ADDENDUM #3

RE: Questions/Concerns & Answers/Clarifications, Revised

Pay Item List and Revised Typical Section

Contract ID: DN00455 County: Polk

Revised Plan Sheet #2, Typical Section

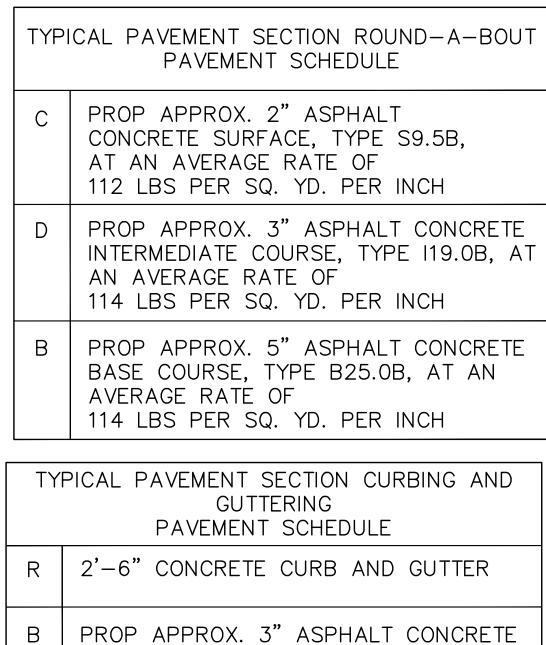
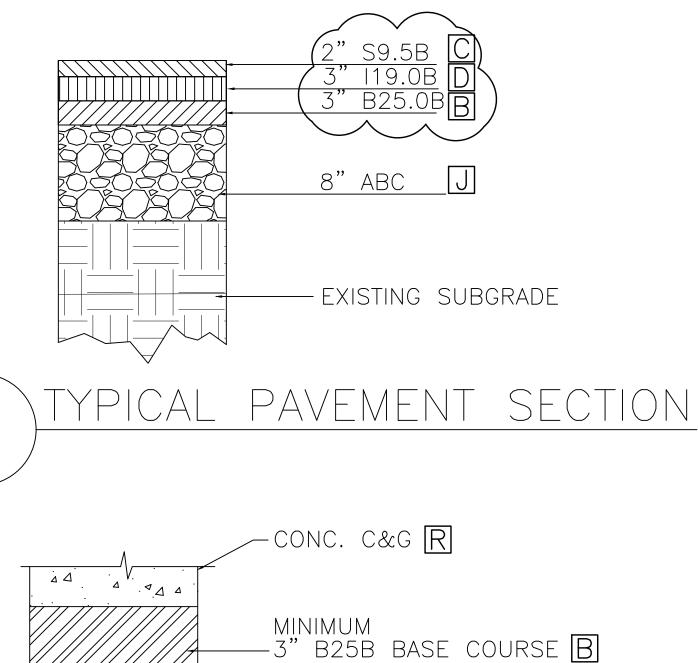
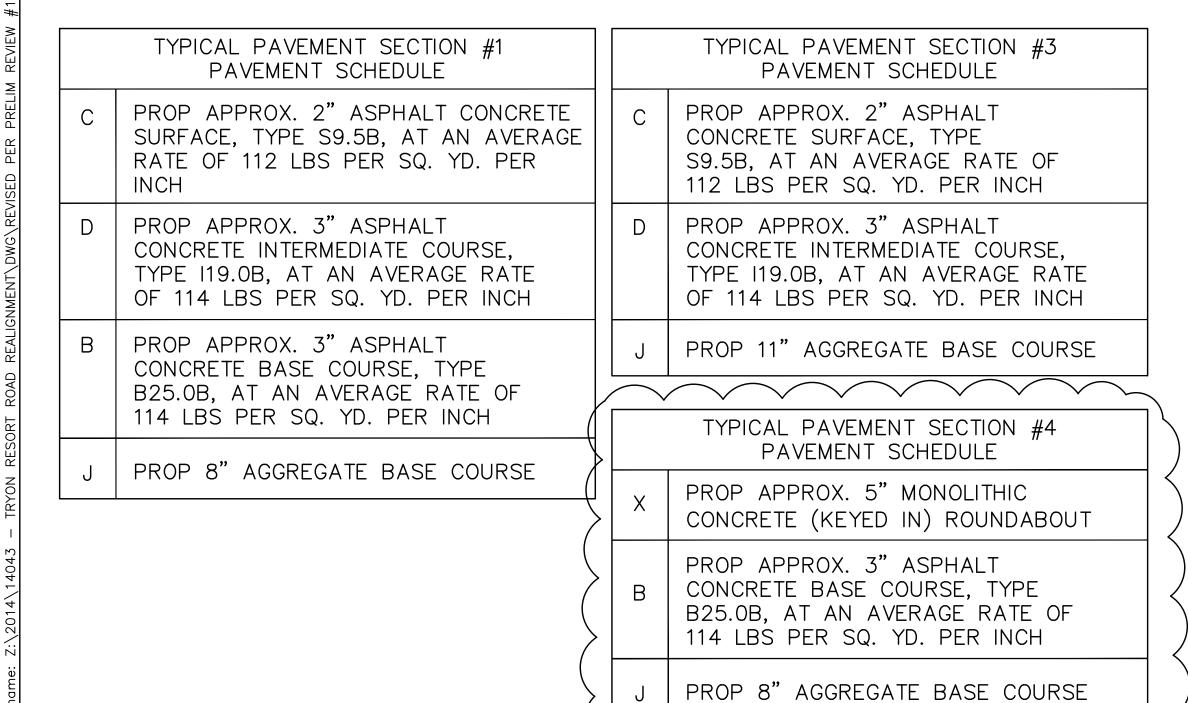
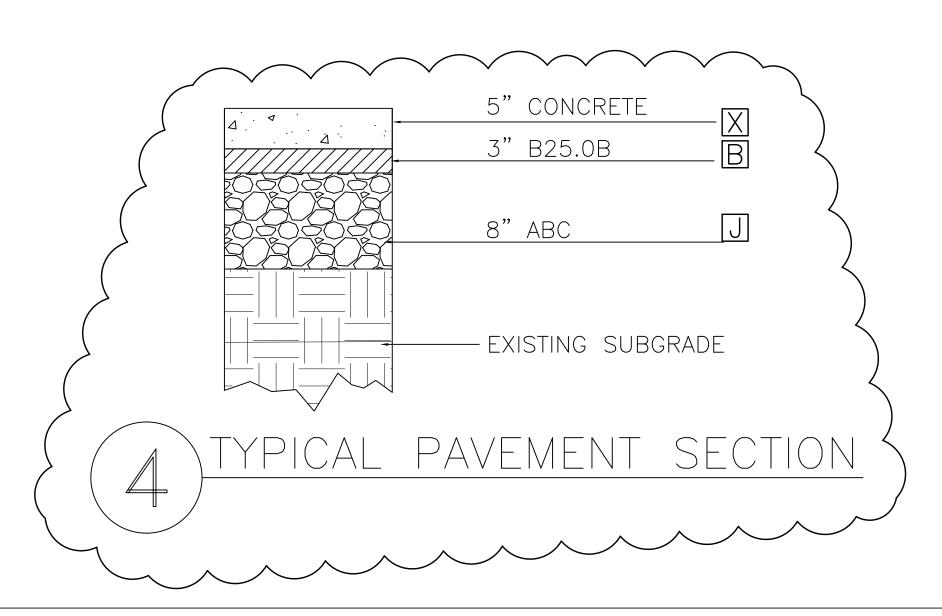
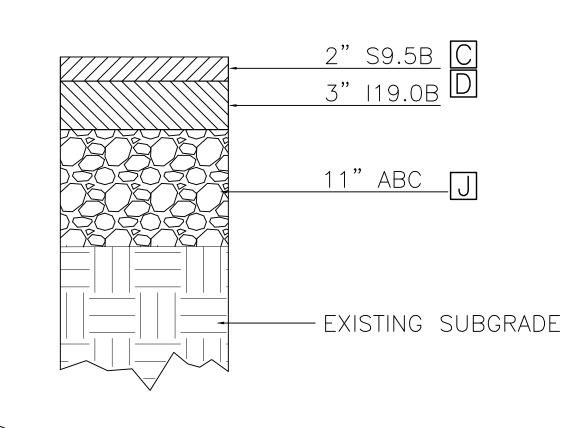
- QUESTION/CONCERN: "On Sheet 2 the Typical Section @ Round-A-Bout has a pavement section of 2" S9.5B, 3" I19.0B, and 5" B25.0B. Beneath this detail is a note that state 'Typical Phase 1-6 Pavement Section'.

- O Phase 1-4 include the round-a-bout as well as all the Ramp A & B construction, all of Pea Ridge Road north of the round-a-bout, and portions of Pea Ridge Road south and John Shehan Road to the bike path. Can you please confirm the intent was to use this section for these areas and not just the 18' thru lane of the round-a-bout?

- Phase 5-6 include areas where Pea Ridge Road south and John Shehan Road tie into existing roads, and include 4' bike paths. Please clarify which typical is to be used in these tie-in locations."

- ANSWER/CLARIFICATION: "The intent was to provide an asphalt surface beneath the roundabout to implement the TCP. A revised sheet 2 is forthcoming"
- QUESTION/CONCERN: "On Sheet 2 the Typical Section #3 is indicated for the 4' bike path which has a pavement section of 2" S9.5B, I19.0B, and 11" ABC. There are certain locations on both Pea Ridge and John Shehan Roads where it appears the bike path stops for turn outs and/or turn lanes. Please

clarify which typical is to be used in the instances, #1 or #3."

- ANSWER/CLARIFICATION: "The entire footprint will be binder. Then traffic will be shifted in quadrants for island and roundabout

construction. The revised typical section (see attached) address some of this concept. Bottom line - the 'temporary asphalt' is included in the B25.0B quantities."

- ANSWER/CLARIFICATION: "The plans have been modified and quantities include 3" B25.0B under the earthen roundabout area for traffic control purposes. The B25.0B quantity has been adjusted to 3380 tons. The line item 0156000000-E Removal of Existing Asphalt Pavement has been increased from 6189 square yards by 805 square yards for a new total of 6994 square yards so that the 3" of B25.0B can be removed from the earthen island area."

ANSWER/CLARIFICATION: "The travel lane typical should remain the same. The bicycle lane typical terminates in the locations shown on the plans. At these locations, the bicycle lane is replaced with earthen shoulder."

See attached revised plan sheet # 2.
